DRAINAGE AND TRANSPORTATION INFORMATION SHEET (REV 3/2018)

Project: Johnston Supply Warehouse
2624 Vassar Dr NE
Albuquerque, NM 87107

Re: Traffic Control Layout Review Comments.

Traffic Control Layout Comment Responses

SET NO:
SHEET TITLE:
TRAFFIC
CIRCULATION
LAYOUT

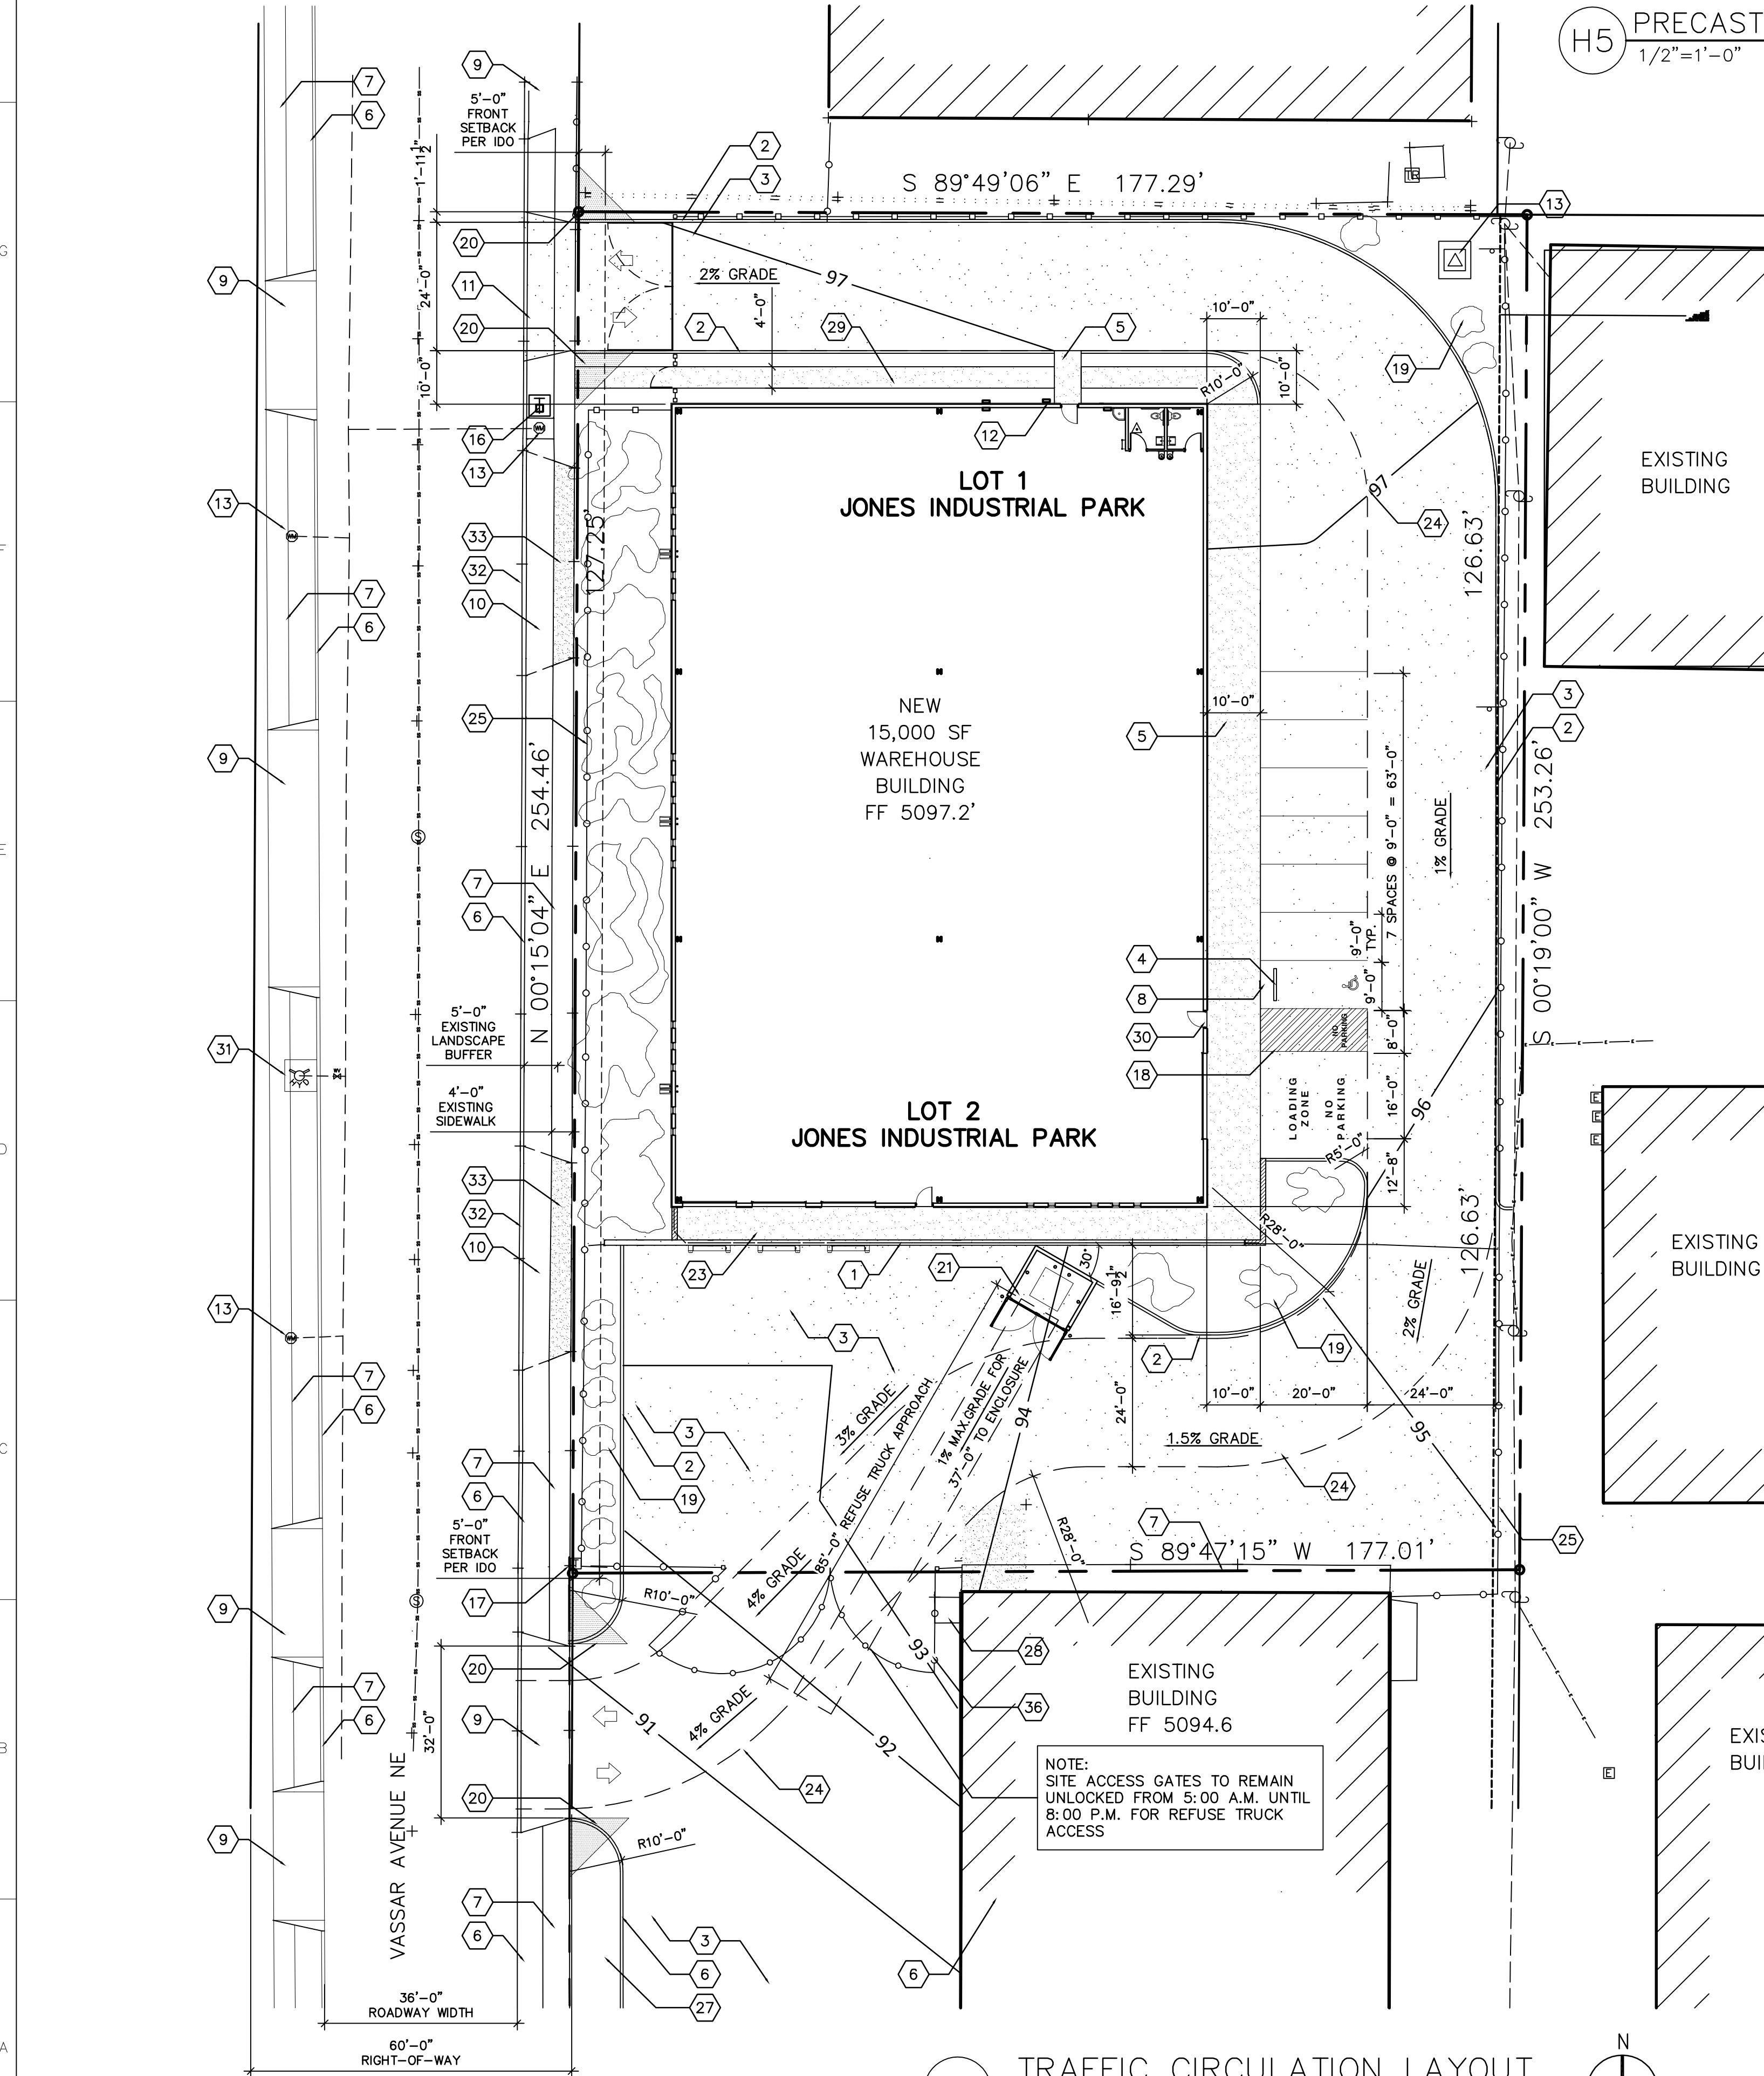
Site accesses must be updated to the current standard. Please provide driveway design details and reference COA std dwg.

The ADA accessible parking sign must have the required language per 66-7-352.4C NMSA 1978 "Violators Are Subject to a Fine and/or Towing." Please call out detail and location of signs.

The ADA access aisles shall have the words "NO PARKING" in capital letters, each of which shall be at least one foot high and at least two inches wide, placed at the rear of the parking space so as to be close to where an adjacent vehicle's rear tire would be placed. (66-1-4.1. B NMSA 1978)

Per the IDO, a 6 ft. wide ADA accessible pedestrian pathway is required from the public sidewalk to the building entrances. Please clearly show this pathway and provide details.

Please show this pathway width on the site plan

Curbing should be installed to delineate landscape, parking, and pedestrian ways and identify points of access. Please call out detail and location of barrier curb.

The clear sight triangle must be shown at the back of the sidewalk and add the following note to the plan: "Landscaping and signage will not interfere with clear sight requirements. Therefore, signs, walls, trees, and shrubbery between 3 and 8 feet tall (as measured from the gutter pan) will not be acceptable in the clear sight triangle.

Unused curb cuts must be replaced with sidewalk and curb & gutter. A build note must be provided referring to the appropriate City Standard drawing.

Add a note stating "All broken or cracked sidewalk must be replaced with sidewalk and curb & gutter." A build note must be provided referring to the appropriate City Standard drawing.

New site access is through curb cut per City of Albuquerque Standard Detail 2425

Detail D6 for signage added to TCL, referenced by Keynote 8 on plan

Lettering added to access aisle on plan. Keynote 18 revised to include lettering specifications.

This project is for a new warehouse. Per IDO Table 5-5-1 there is no parking requirement for this building. Per ABQ DPM Section 7-4(E)(2)4: Commercial or multi-family developments requiring 5 or fewer parking spaces shall provide a minimum 4 foot walkway. A 4 foot wide concrete walkway is provided on the north side of the building. Detail D1 added to sheet for typical sidewalk edge.

Dimension added to plan as requested.

Detail D7 added to sheet for typical barrier curb. Locations referenced on plan by Keynote 2.

Clear sight triangle shown on plan and referenced by Keynote 20. Keynote includes the requested language above.

Plan revised to clarify removal of unused curb cuts and replacement with sidewalk and curb & gutter. Keynotes 32 and 33 for new sidewalk and curb & gutter include reference to appropriate City of Albuquerque Standard Drawings.

Keynotes 6 & 7 revised to include notes for replacement of broken or cracked sidewalk or curb & gutter with appropriate City of Albuquerque Standard Drawing references.
